PACIFIC PARK SUBD. BLAUVELT ADDITION,

**ITEM #2 – PRELIMINARY PLAT
PACIFIC PARK SUBDIVISION BLAUVELT ADDITION**

KPB File No.	2023-088
Plat Committee Meeting:	August 28, 2023
Applicant / Owner:	Walter and Brandi Blauvet of Anchor Point, Alaska
Surveyor:	Dmitri Kimbrell / Fineline Surveys
General Location:	Anchor Point area / Anchor Point APC

Specific Request / Scope of Subdivision: The proposed plat will subdivide a 5.160 acre parcel into two lots ranging in size from 1.956 acres and 3.203 acres.

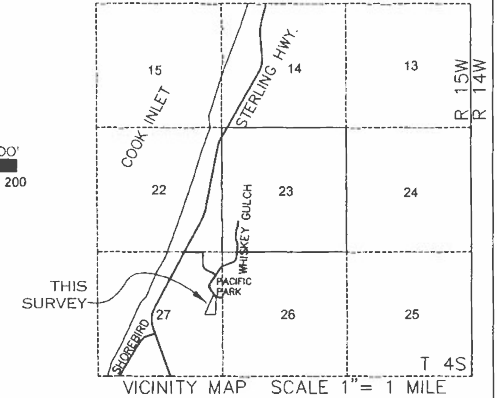
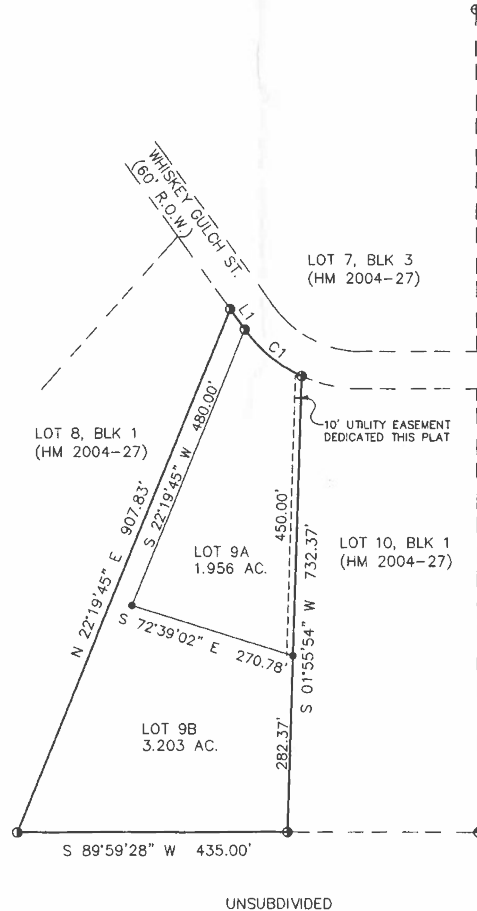
Block length is not compliant due to wetlands to the south and unsubdivided parcel to the south and east. Until future subdividing occurs this plat cannot improve the block lengths. ***Staff recommends: the plat committee concur an exception is not needed.***

Site Investigation: This area is covered by large portions of wetland classification from the Kenai Watershed Forum. Staff would like to remind the surveyor that approximate locations of low wet areas, areas subject to inundation are required on preliminary submittals. If showing the information makes information hard to read a supplemental map would suffice. ***Staff recommends: any wetlands or areas subject to inundation be shown on the final plat.***

This subdivision is in a Flood Hazard Area and ***staff recommends the correct plat note be shown with the map panel information provided by the Floodplain – Planner be included.***

KPB satellite imagery indicates this property may contain wet areas. **Staff recommendation:** place a note on the final plat indicating any person developing the property is responsible for obtaining all required local, state, and federal permits, including a U.S. Army Corps of Engineers wetland determination if applicable.

Plat note #9 indicates the driveway will be located in the panhandle portion of Lot 9B and will be a share access for both lots. Staff recommends to be added to the note, that a joint access agreement be drawn up when new ownership of the lots occurs.

The parent plat, HM 2004-24, granted 10-foot utilities along all rights-of-ways and the correct note has been carried over. This easement should be shown on the drawing.

The plat is proposing a 10' utility easement along the east line of Lot 9A. HEA has reviewed and made the comment to increase the easement to 15' wide as that is standard width.

The Certificate to Plat indicates there is an easement for the benefit of Homer Electric Association, Inc and is reflected within plat note five. **Staff recommends:** all plat notes referencing recorded documents include "Homer Recording District" in the note.

HEA	Revise the easement width to 15' as this is the standard width for underground electric service installation.
ENSTAR	No comment
ACS	
GCI

Show building setback on drawing
Needs distances and bearings to tie to the pins to the east.

- Staff recommendation:** Add block designation and KPB file number 2023-088.
- D. A vicinity map, drawn to scale showing location of proposed subdivision, north arrow if different from plat orientation, township and range, section lines, roads, political boundaries, and prominent natural and manmade features, such as shorelines or streams;

- Staff recommendation:** Add Street to Whisky Gulch and remove Pacific Park.

- J. Block and lot numbering per KPB 20.60.140, approximate dimensions and total numbers of proposed lots;
Staff recommendation: Add block 1 to label

Platting Staff Comments: a soils analysis will be required and an engineer will need to sign the final plat.
Staff recommendation: comply with 20.40.

Staff Discussion: A flag lot with the access portion less than 60 feet wide may be subject to a plat note indicating possible limitations on further subdivision based on access issues, development trends in the area, or topography. If the access portion is less than 60 feet wide, it may not exceed 150 feet in length. The access portion may not be used for permanent structures or wastewater disposal area

1. Large classified wetlands in the area.
2. The panhandle will be the shared driveway for both proposed lots.
3. No permanent structures can be constructed in the panhandle.
4. The width of the panhandle is 40.30 feet.
5. The length of the panhandle is 480 feet.
6. Both lots have large buildable areas still.
